**Sterling Drug Inc.**  
**Site Number 3**  
**I.D. Number 442011.**

# **Record of Decision**

Sterling Drug Inc., Site #3  
Riverside Ave.  
Town of East Greenbush  
Rensselaer County, New York  
Inactive Hazardous Waste Site Code : 442011

RESPONSIVENESS SUMMARY FOR PROPOSED REMEDIAL ACTION PLAN  
STERLING DRUG SITE #3  
TOWN OF EAST GREENBUSH  
RENSSELAER COUNTY, NEW YORK  
ID # 442011

FIGURE 4

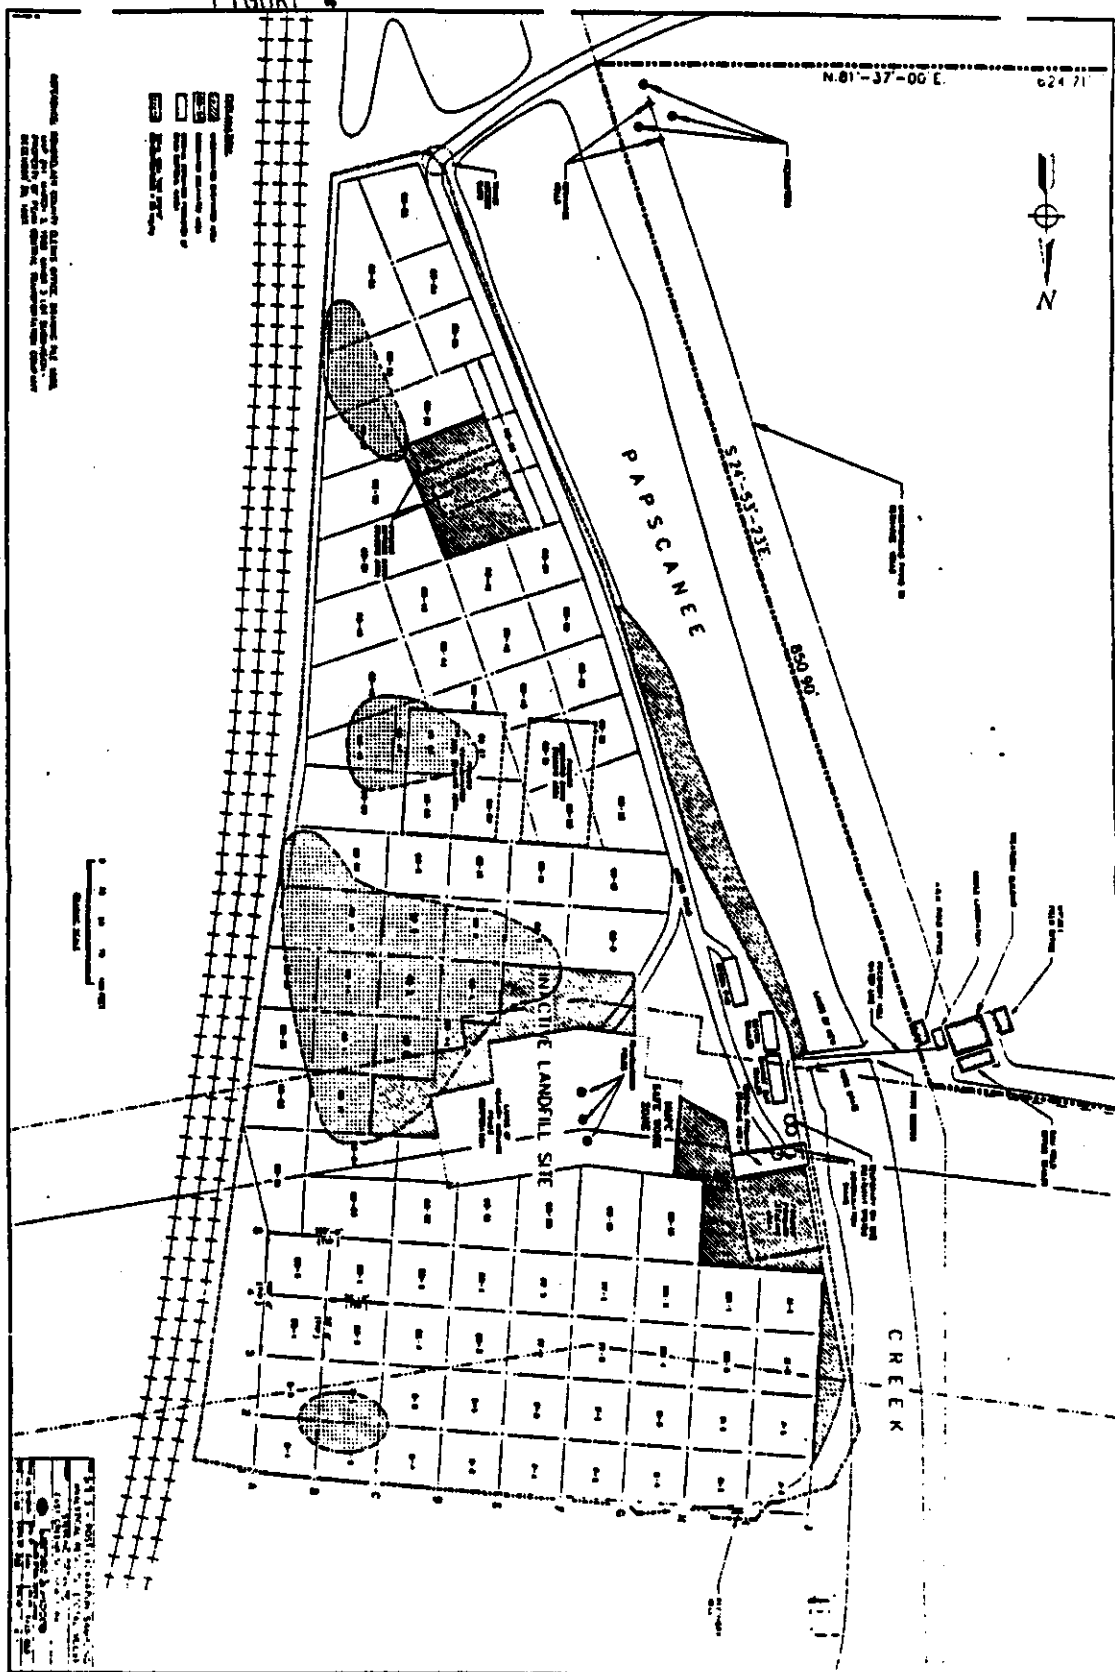
7. Page 4, second paragraph - "At present, these risks are minimized because the heavily contaminated soils are only present at depth." Please provide a definition of "heavily contaminated" in the RAP. (Refer to General Comment Number 3).

At this location in the PRAP the terms "heavily contaminated" were referring to the area where the free product was found, the Clay Breach Area(CBA) as explained in general comment number 3. This paragraph also indicates where higher concentrations of contaminants were found by referencing Figure 4 of the PRAP.

TITLE	MINIMUM GROUNDWATER ELEVATIONS WITH ZONE OF CAPTURE - 30 GPM		
PROJECT	STERLING ORGANICS - SITE 3 EAST GREENBUSH, NEW YORK		
	 <b>Dames &amp; Moore</b> WILLOW GROVE, PENNSYLVANIA		
SCALE	AS SHOWN	DWN. BY	EM <sup>2</sup>
DATE	10/2/91	APPR. BY	R.D.
		JOB NO.	7425-068
		FIG. NO.	1-44

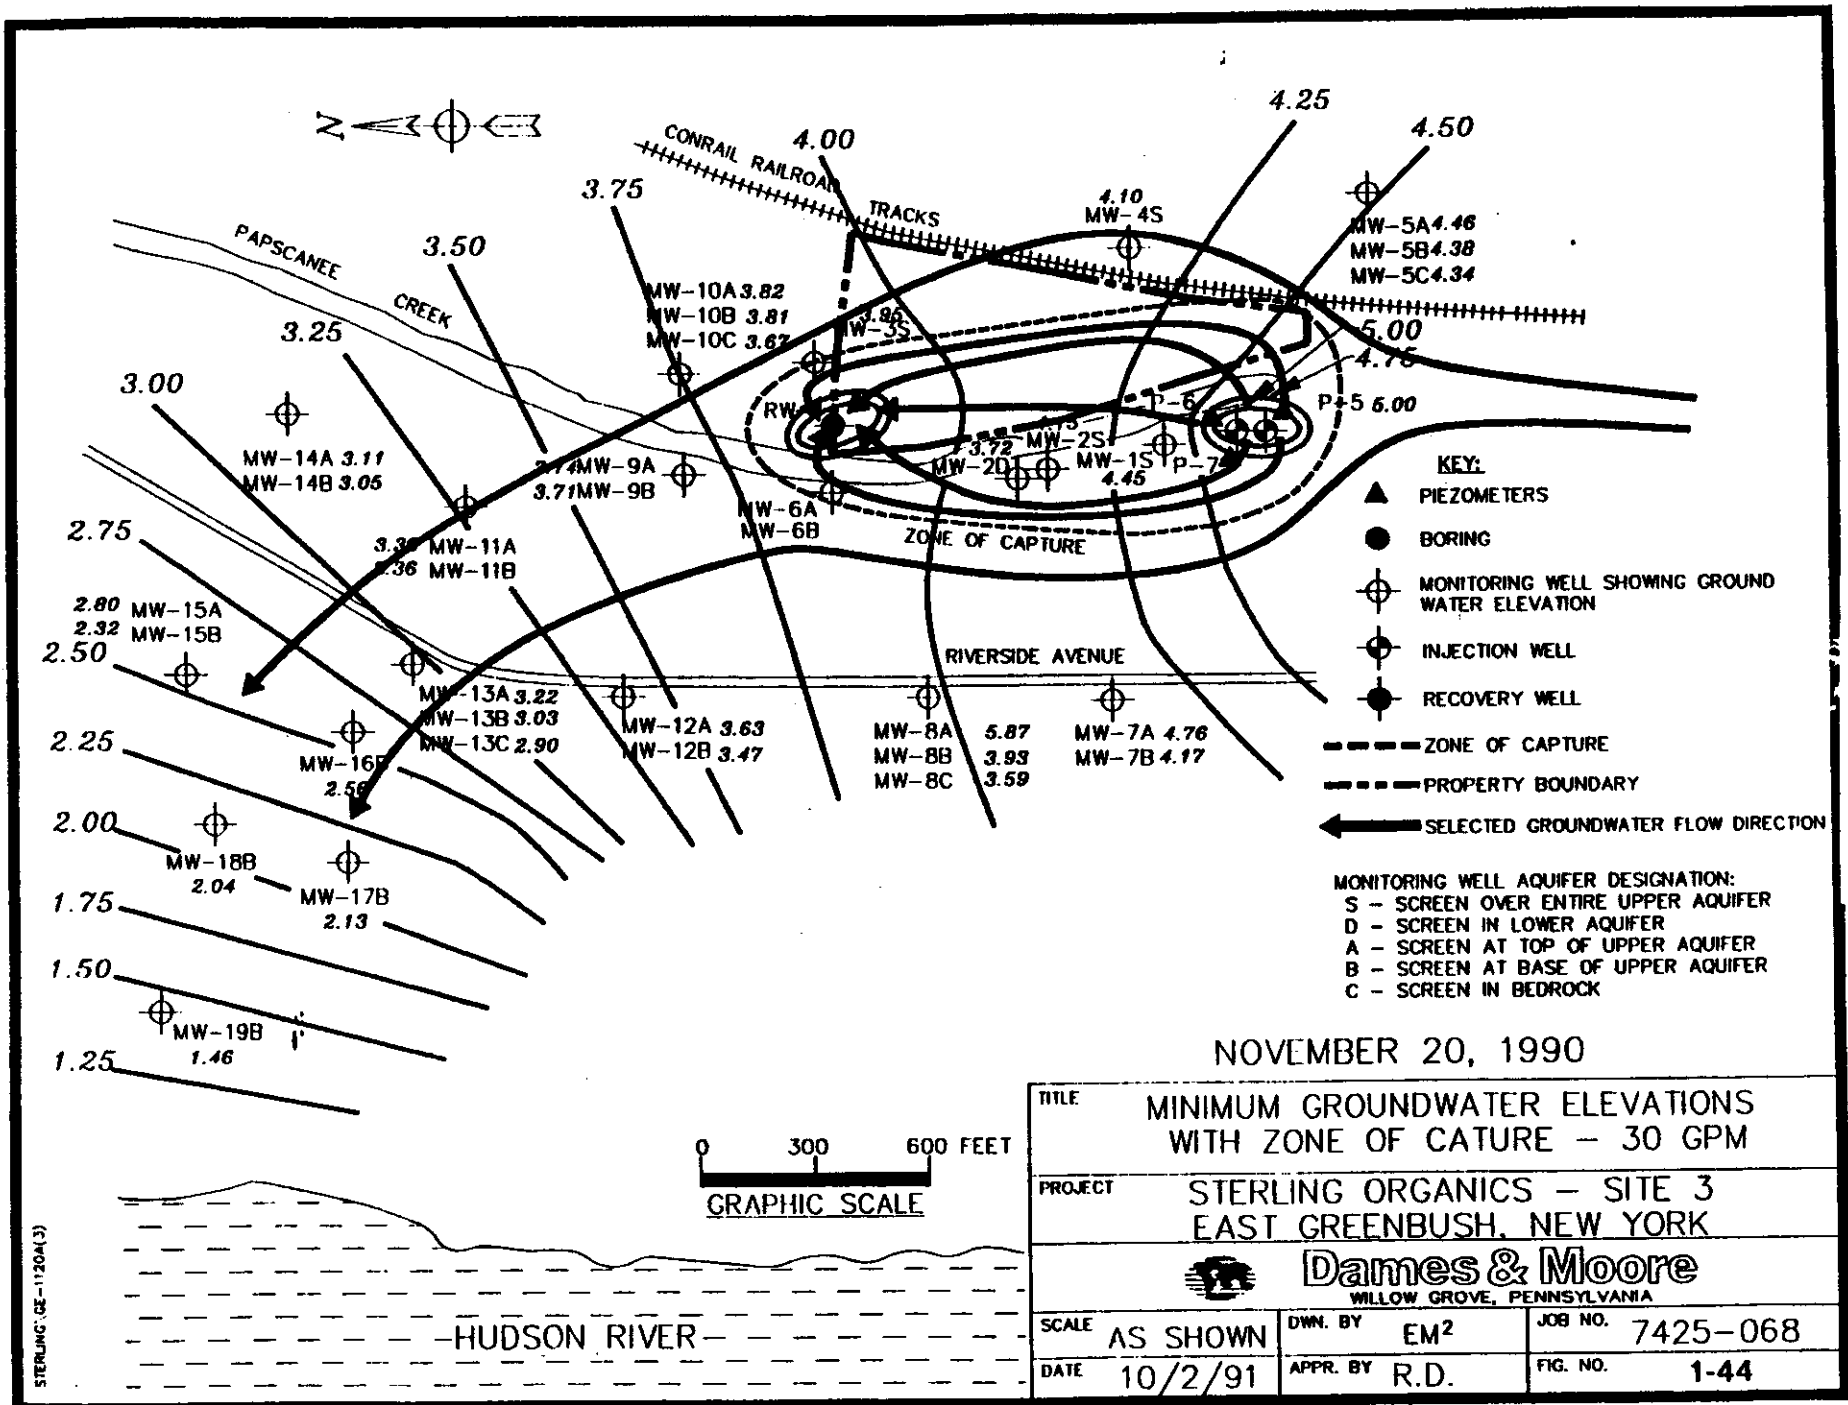
1. The delineation between the onsite and the offsite plume is not evident in the Proposed Remedial Action Plan (PRAP). Collection and containment of the onsite plume is currently being performed, and has been successful at reducing contaminant concentrations in the groundwater beneath the site and eliminating further contaminant migration. The diethyl ether in the offsite plume migrated from the site prior to the initiation of groundwater recovery activities, and is outside of the zone of influence of the existing recovery well. The text should be revised to further illustrate the differentiation between the two plumes.

In order to clarify the actual situation at the site, the language will be modified. There is actually only one plume and the current groundwater treatment system is only collecting and treating a portion of it. As far as differentiation of the two sections of the plume the language will be modified and figures will be added to indicate the zone of influence of the treatment system.
